In Support Comment 222, 226, and 228

IEEE 802.3bj Task Force

Ali Ghiasi - Broadcom

Nov 13-15, 2012

QSFP28 MCB-HCB Crosstalk

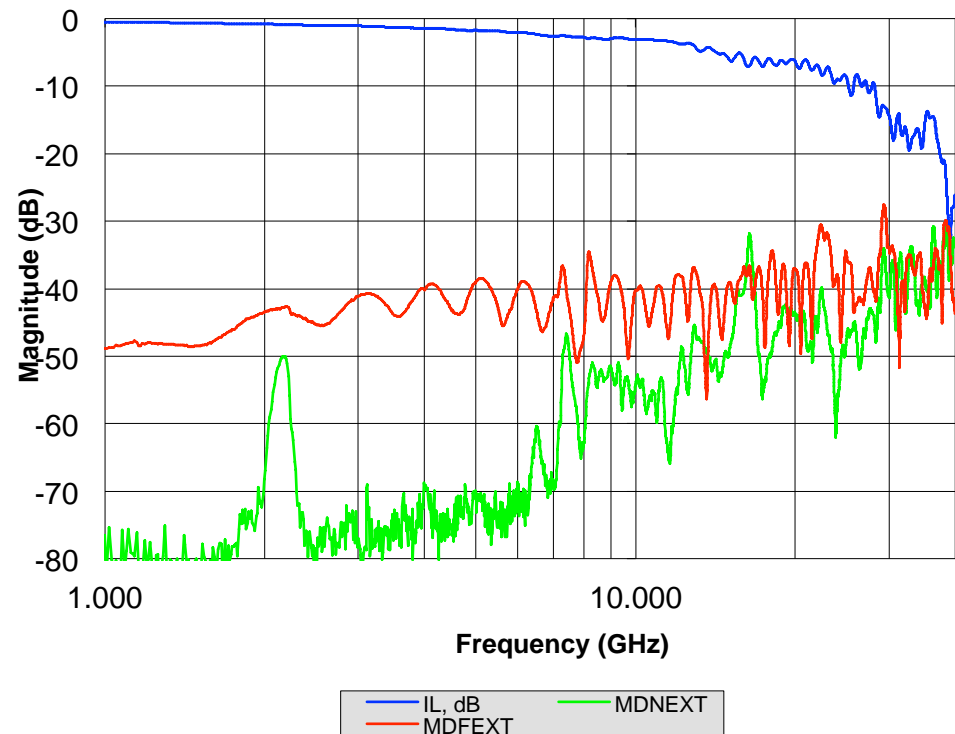
- Addressing comment 226
 - Include 4 NEXTs and 3 FEXTs
 - As the board loss has gone down crosstalk has increased

Transmitter and Receiver Differential Host Board Loss

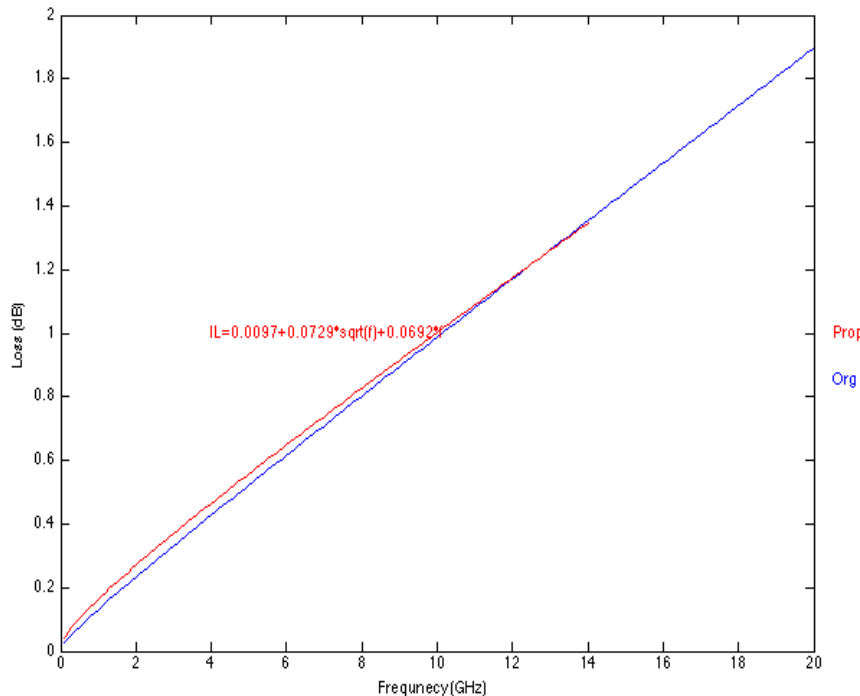
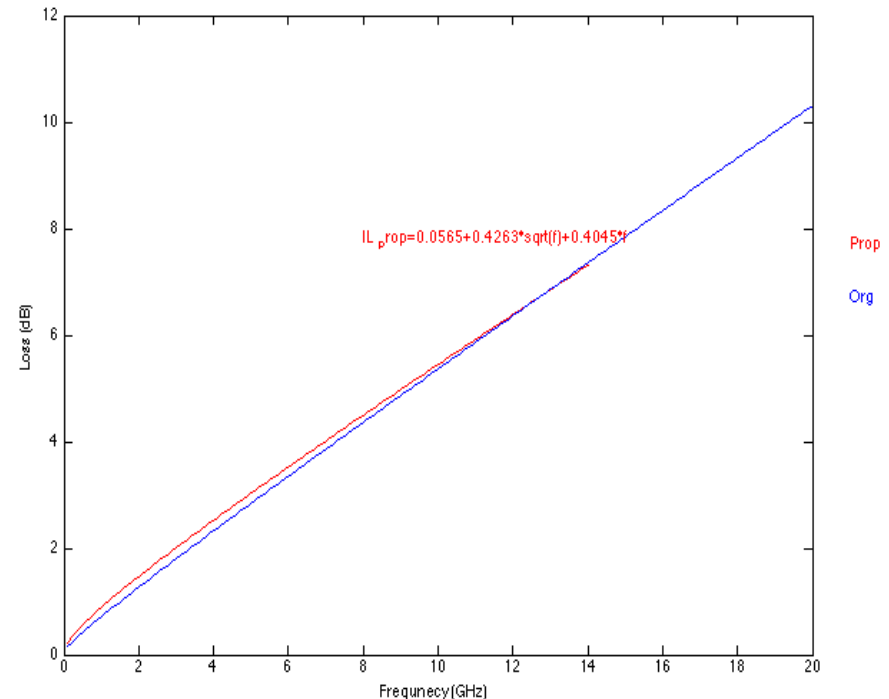
- Addressing comment 228
 - Current differential PCB loss is not consistent with the channel TP0-TP2 or TP3-TP5
 - Equation 92A-1 and 92A-2 linear term is >2x the sqrt term
 - But the channel loss Eq 92-4 linear term ~ as the sqrt term
